Alta Drive Improvements (Desert foothill to Fox hill)

PROJECT: Summerlin Village 23A/23B -update #3

CITY OF LAS VEGAS		DATE:
INTER-OFFICE MEMORANDUM		September 25, 2012
TO: Land Development Services Department of Public Works		FROM: Albert Sung, P.E. Flood Control Project Engineer Department of Public Works
SUBJECT:	COPIES TO:	
Drainage Study for:	G. C. Wallace Inc.	
Alta Drive Improvements (Desert Foothill to Fox Hill) Summerlin Village 23A/23B – Update #3		
Cross Streets:	Alta Drive between Desert Foothill & Fox Hill	Howard Hughes Corporation
File Number:	F:\Depot\DSMemos\DS4571A.doc	Bart Anderson, P.E., DevCo
Parcel Number:	137-22-000-015	CCRFCD
Zoning Action:	N/A	
FEMA Flood Zone	YES	NO X
Proposed Storm Drain	YES X	NO

**RESPONSE TO COMMENTS
ON THE UPDATE TO THE
TECHNICAL DRAINAGE STUDY
FOR
SUMMERLIN VILLAGE 23A/23B
ALTA DRIVE STREET IMPROVEMENTS**

FIGURE 5 (REVISED)
PROPOSED DRAINAGE FACILITIES MAP

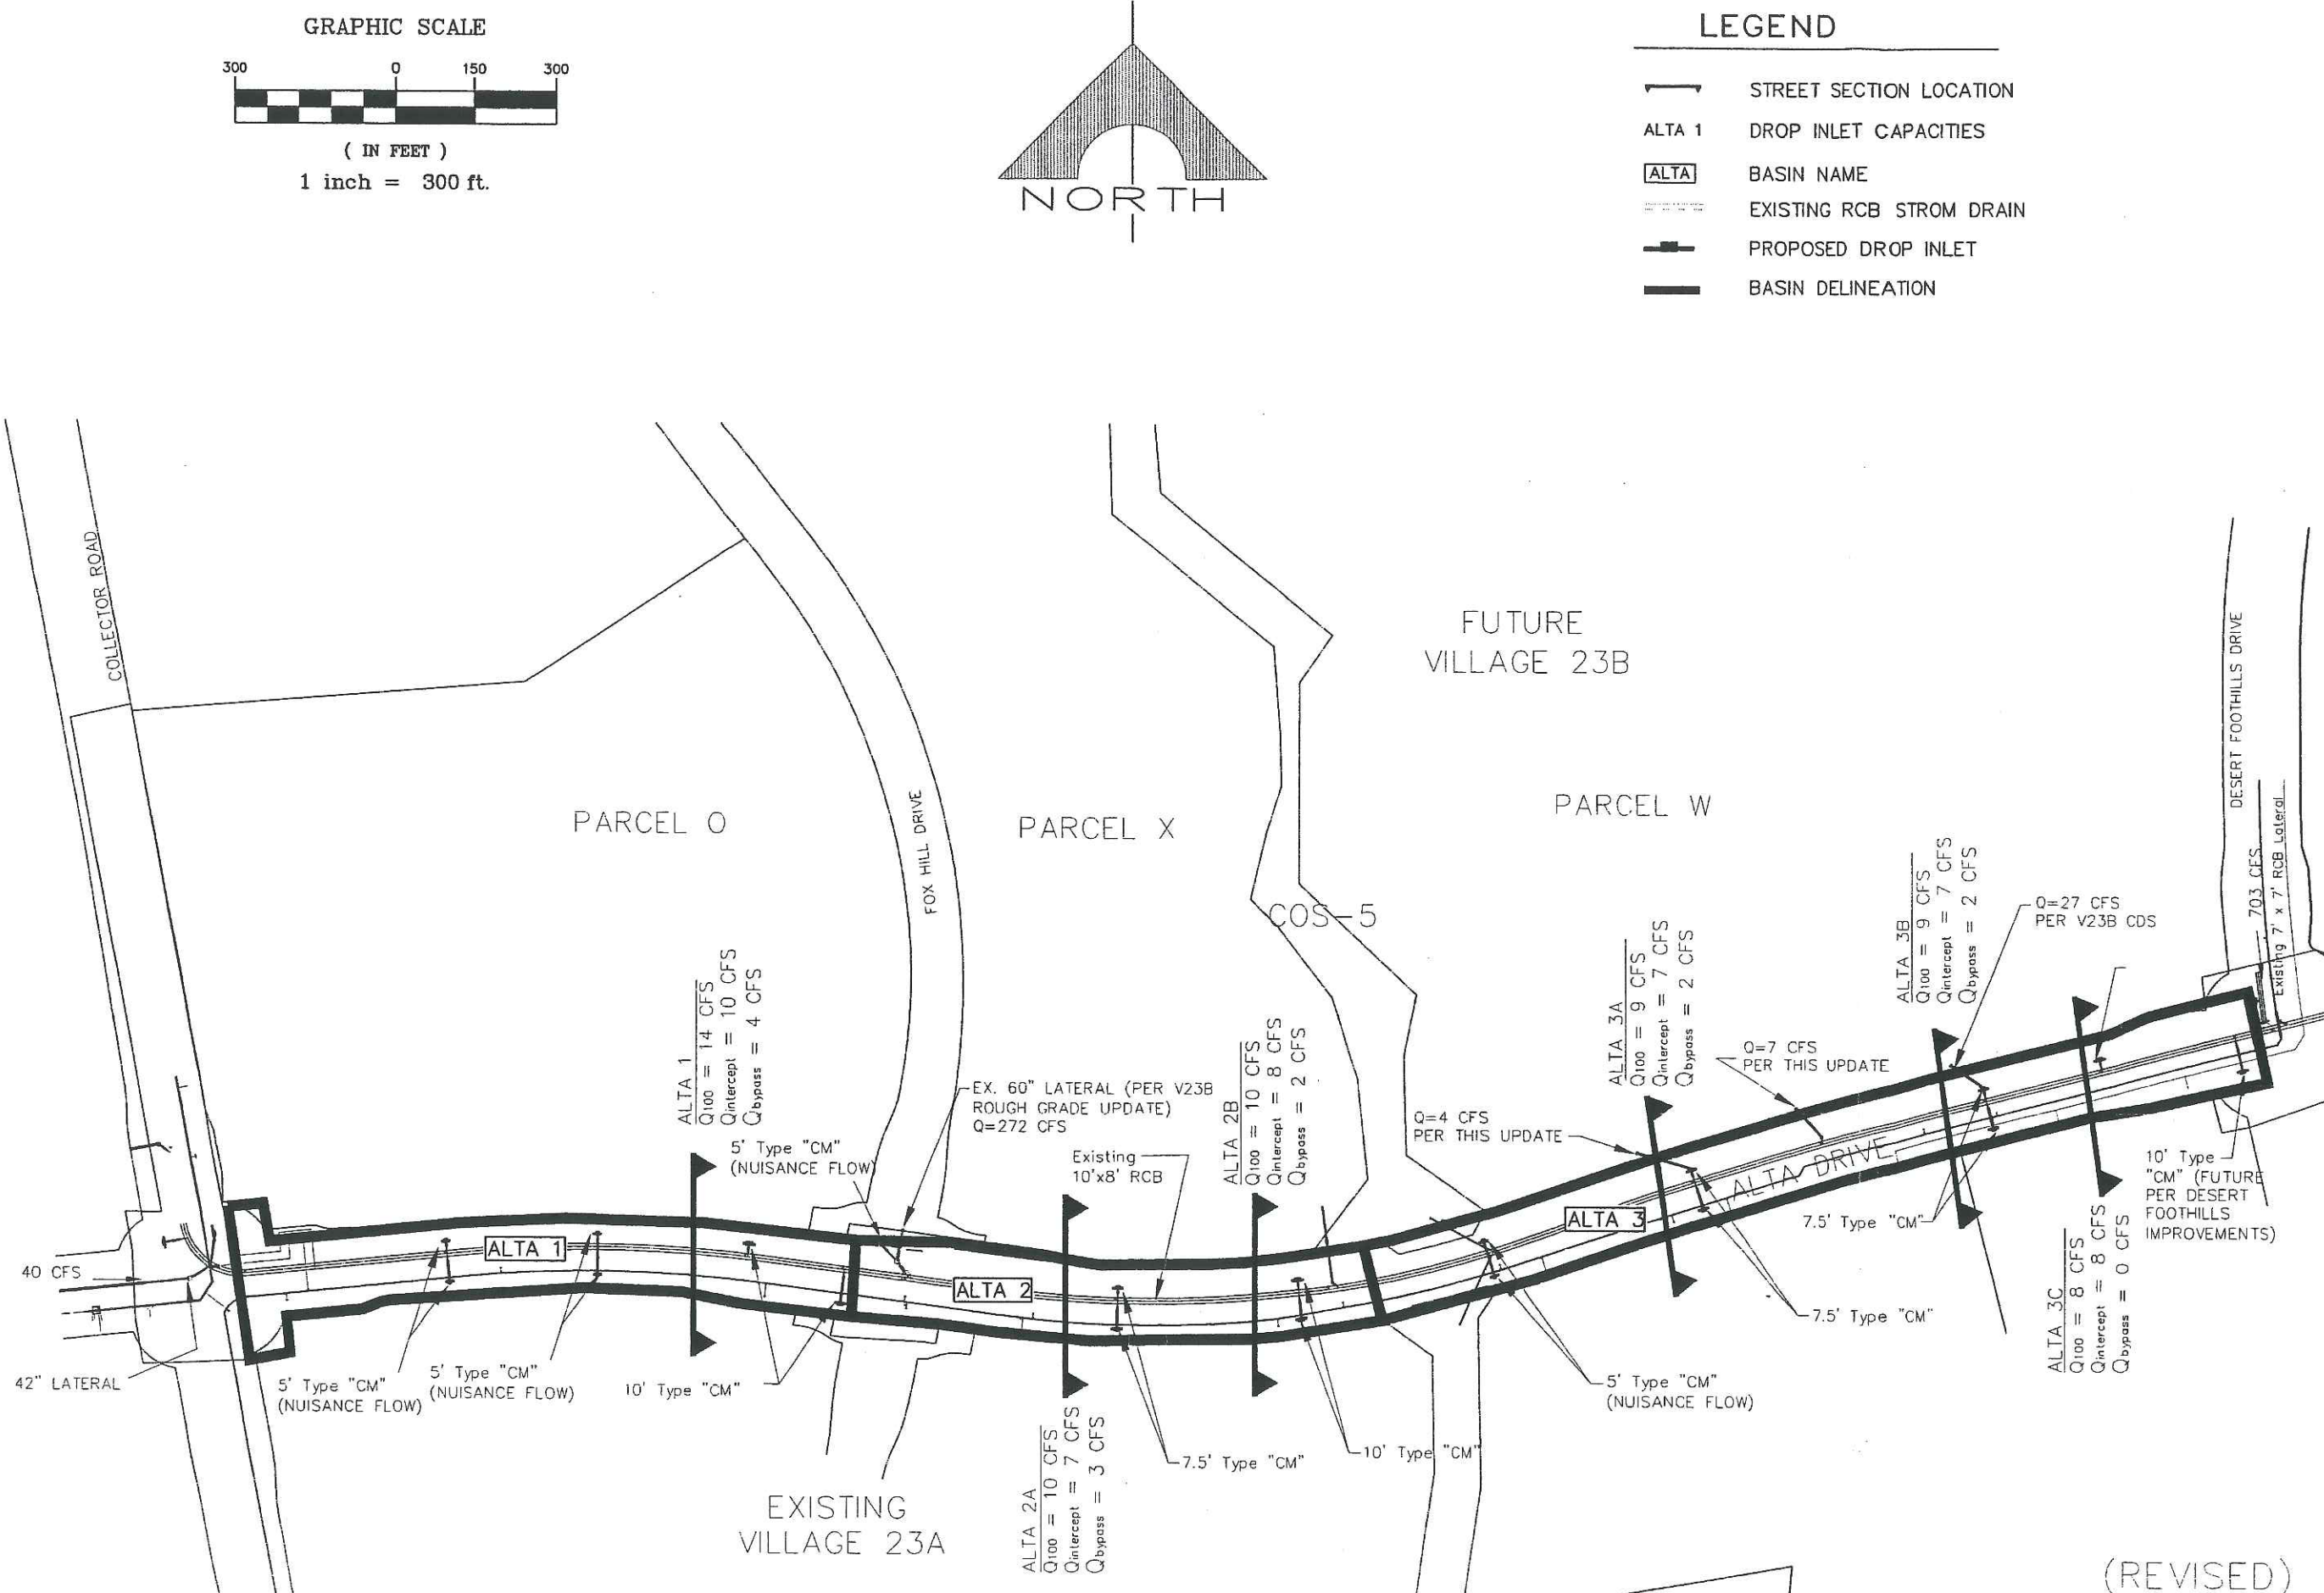
The proposed drop inlet and the extension of the 24-inch laterals locations are shown on Figure 5. The Alta Drive RCB storm drain system was designed already taking the street flow intercepted by the drop inlets into account. Hydraulic calculations for the

*See Figure 5 (REVISED).

In addition to the drop inlet revisions, minor lateral revisions at three locations have been made to the storm drain improvements to accommodate the future development of Parcels W and X within Village 23B. At Station 205+73 the proposed 30-inch lateral will now connect to the proposed drop inlet at an angle versus perpendicular. At Station 208+90.6 the proposed 24-inch lateral will connect to the existing 24-inch lateral at an angle via a proposed storm drain manhole. At Station 211+41 an additional 24-inch lateral will connect to the proposed drop inlet. Please refer to the revised plans included in the appendix.

SUMMERLIN
VILLAGE 23A/23B ALTA DRIVE IMPROVEMENTS
FOX HILL DRIVE PLAN AND PROFILE
STA 230+00 TO 238+00

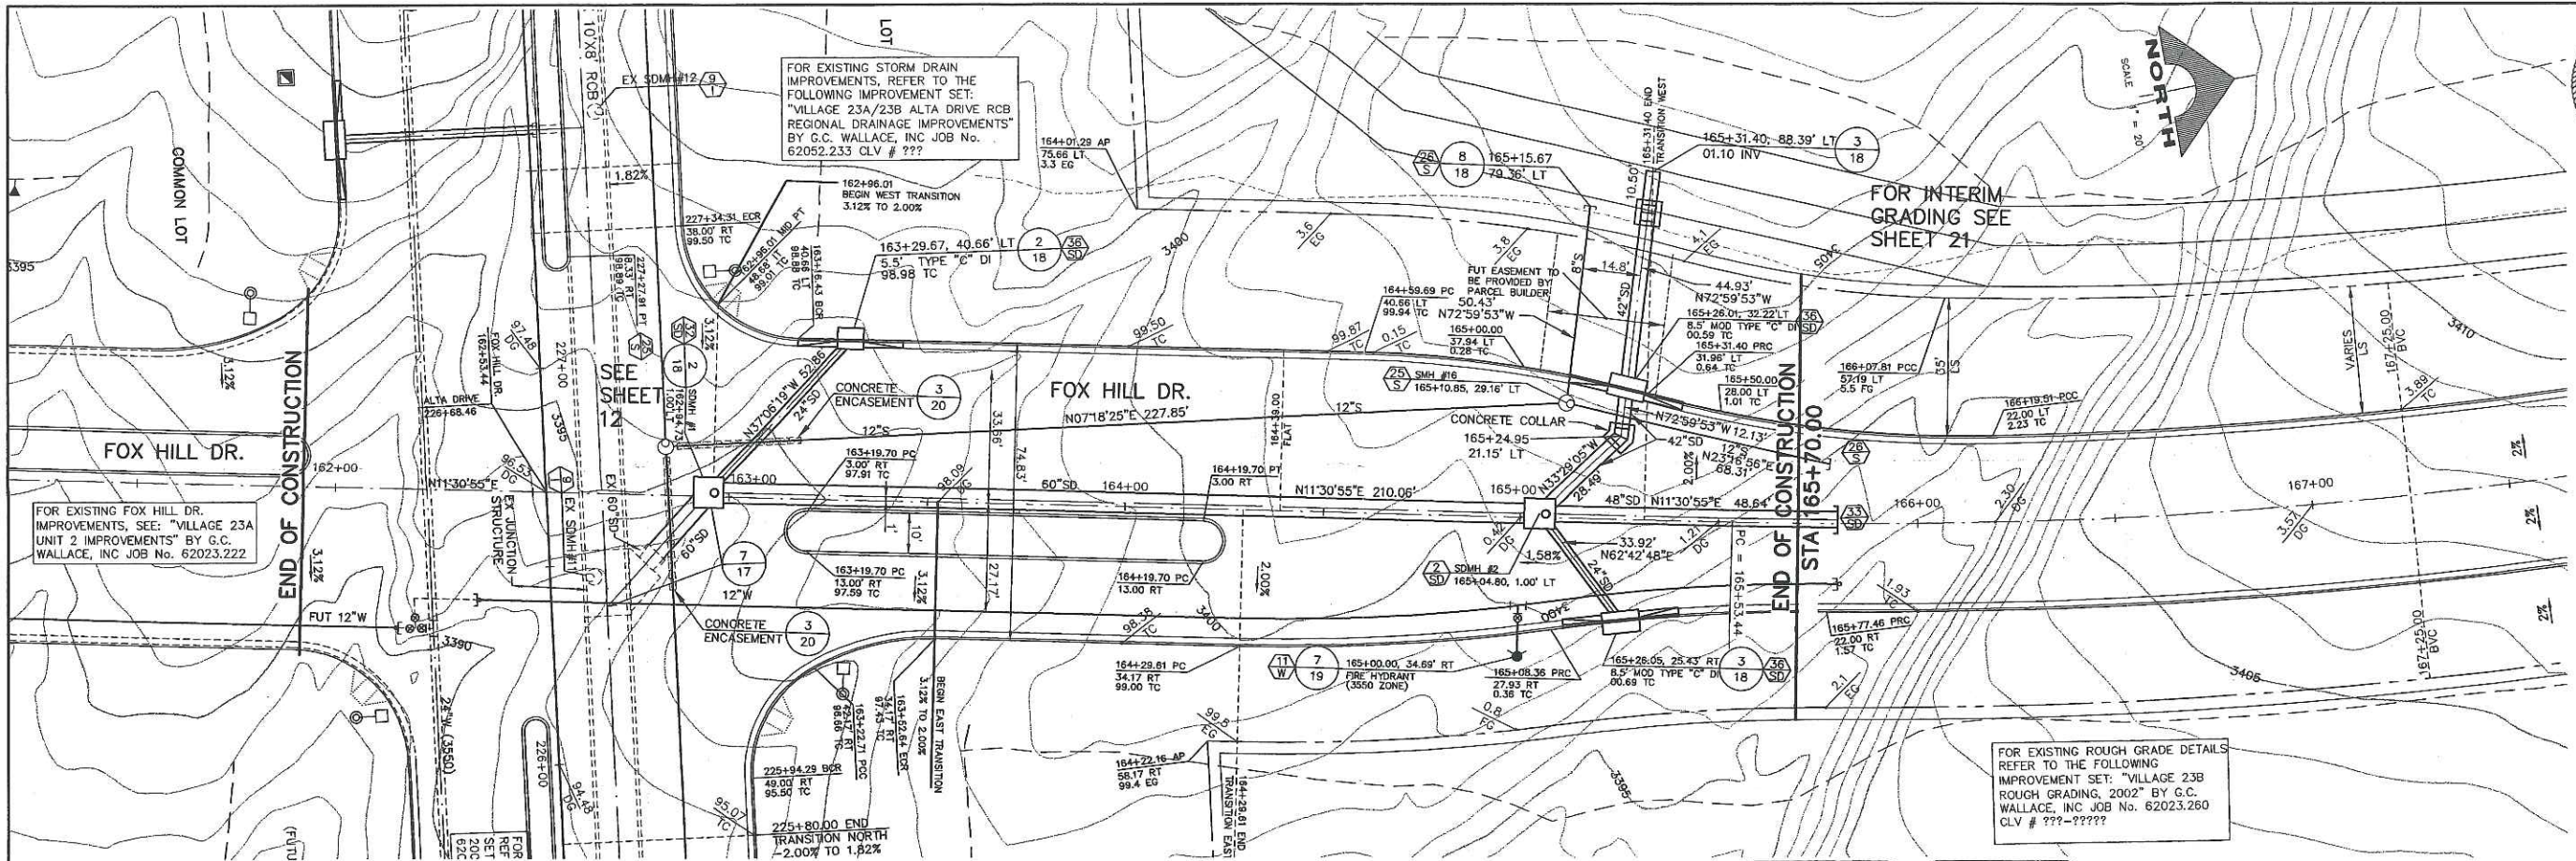
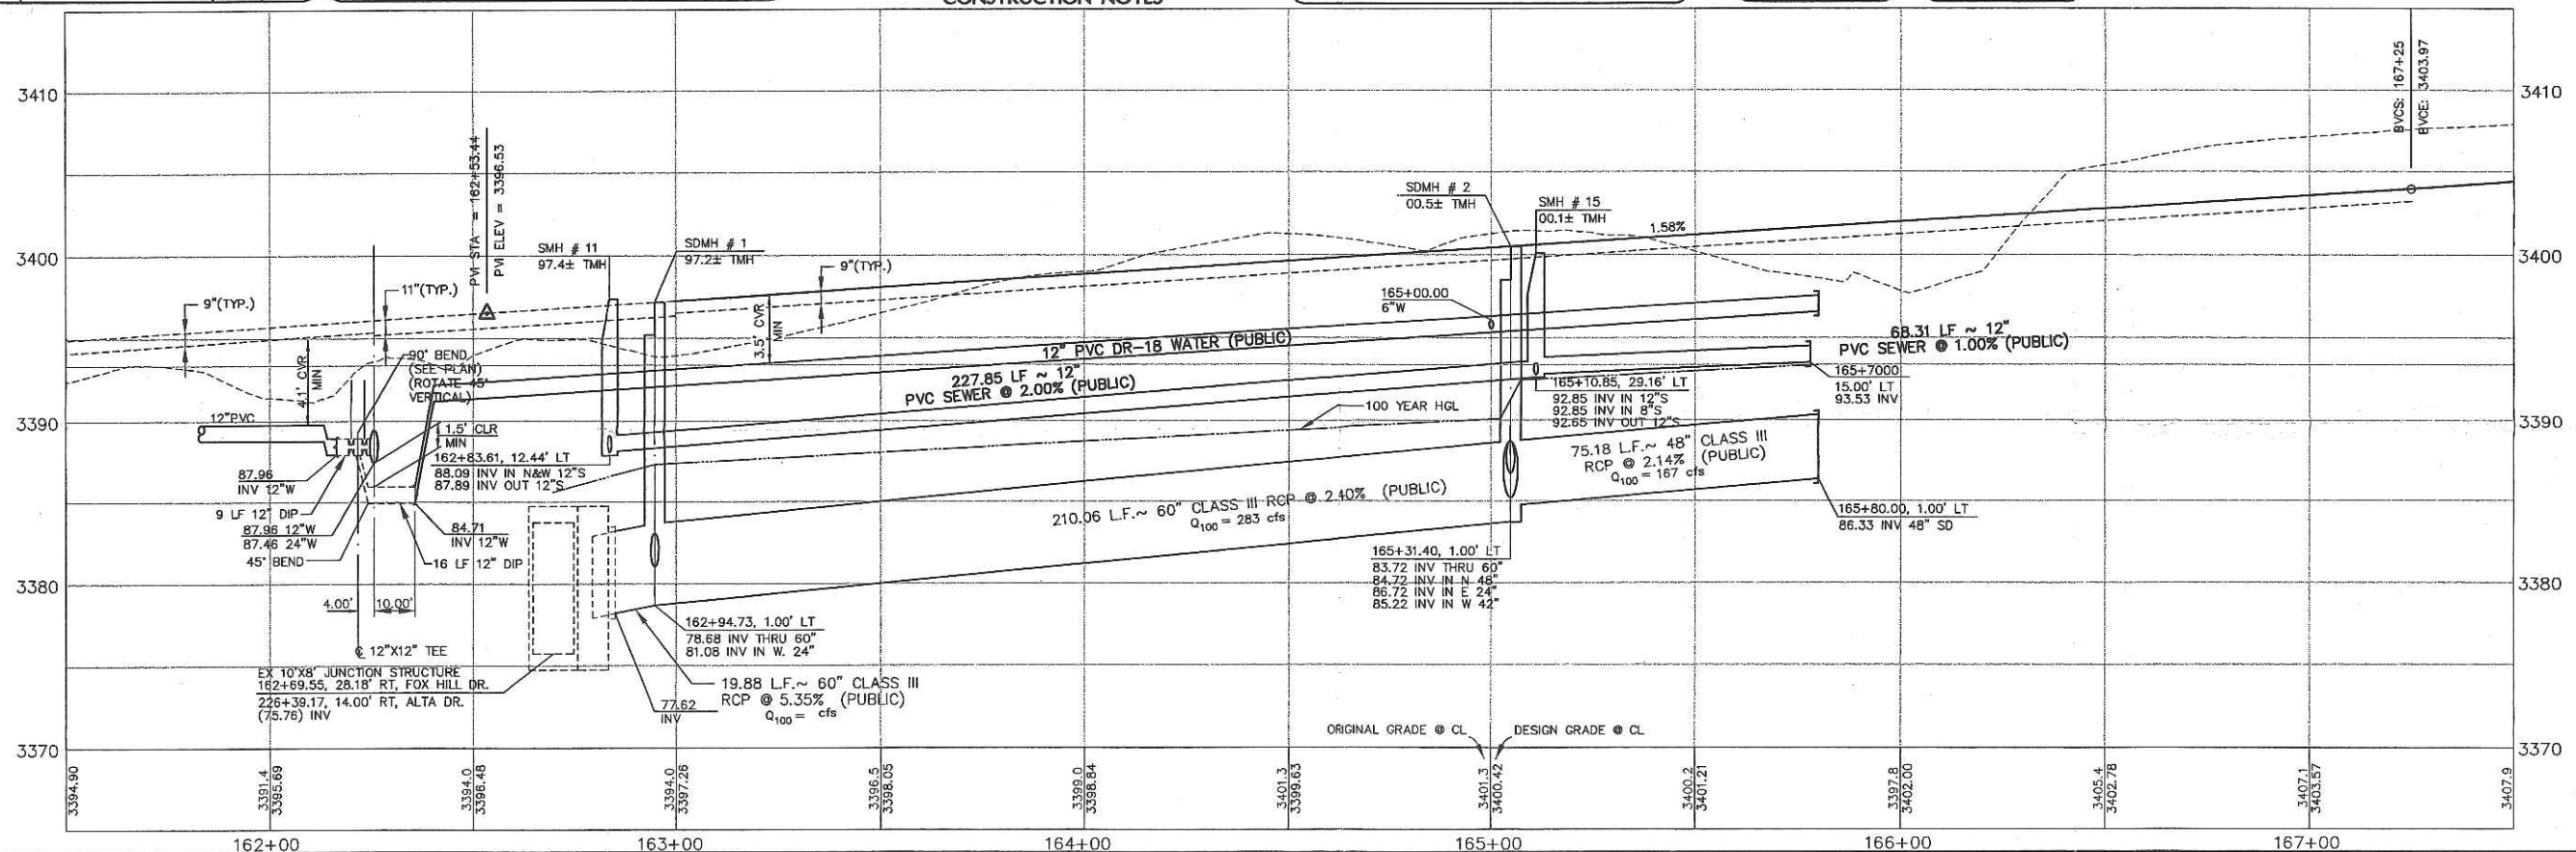
These two facilities are also commented in the following plan & profile drawings.
- Sheet 9:** Identify an existing 36" stub between Parcel P and Parcel Q. Review and revise all pertinent plans accordingly.
- Sheet 13:** Identify the 42" stub at the intersection of *Alta Drive* and the future *Fox Hill Drive*.
- All the interim facilities such as but not limited to the openings, berms/channels and laterals etc. are owned and to be privately maintained by *Howard Hughes Corporation*.
